Rye Park Wind Farm - Modification 1 - Tip Height Increase

I refer to your request for advice regarding the Rye Park Wind Farm Modification 1 (SSD-6693 Mod 1). The modification proposes to amend the project approval by removing 12 wind turbines, increasing the wind turbine envelope to a maximum tip height of 200m, revising the development corridor, and the selecting of the preferred transport route.

Attachment A

Figure 1 Background noise at the receiver vs wind speed at wind farm

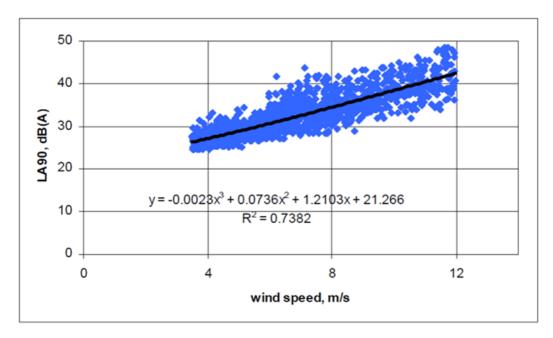
It is clear from this typical regression that a higher wind speed at hub height (x-axis) is correlated with a higher background noise level at a receiver location (y-axis). Typically, wind speed increases with height. For this reason, the relationship presented in the graph above only holds true for the hub height being considered in the analysis and cannot be used without justification for revised hub heights. This is important because noise criteria is derived based on this relationship, and it is important to ensure that the background noise level at the receiver is correlated to the correct hub height.
